# TECHNICAL SERVICE BULLETIN

NO. 3 D 14

Freewheeling on Over-Run/  
Sticking in Overdrive

MGB) Overdrives  
MGC)

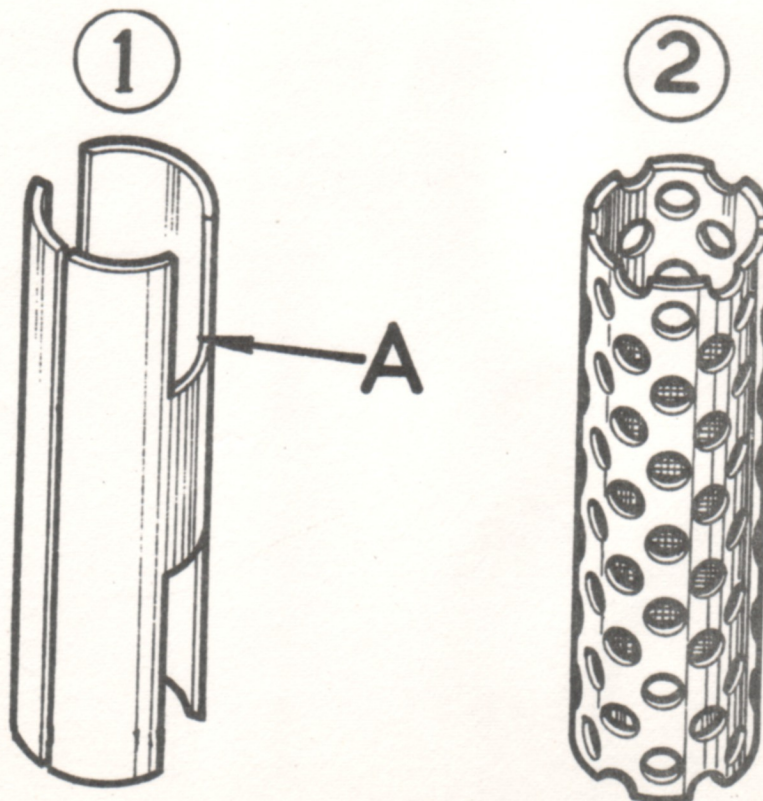
This may be due to the cut away 'A' (Fig. 1) of the original type relief valve spacer tube restricting the oil port in the valve bore, or to damaged seals on the operating valve housing or solenoid plunger.

1. Replace any damaged seals on solenoid plunger or operating valve housing and ensure that solenoid action is not being impaired by the presence of swarf, etc.
2. Remove the relief valve assy and if of the earlier type, replace it with an assembly incorporating the modified spacer tube as shown in Fig. 2.
3. Before re-fitting the relief valve plug, carry out a pressure test as detailed in the Workshop Manual to ensure that the correct pressures are being obtained.

Modified relief valve spacer tubes (Fig. 2) were introduced at the undermentioned Serial numbers, these items being included with relief valve assemblies obtainable under their original Part Numbers.
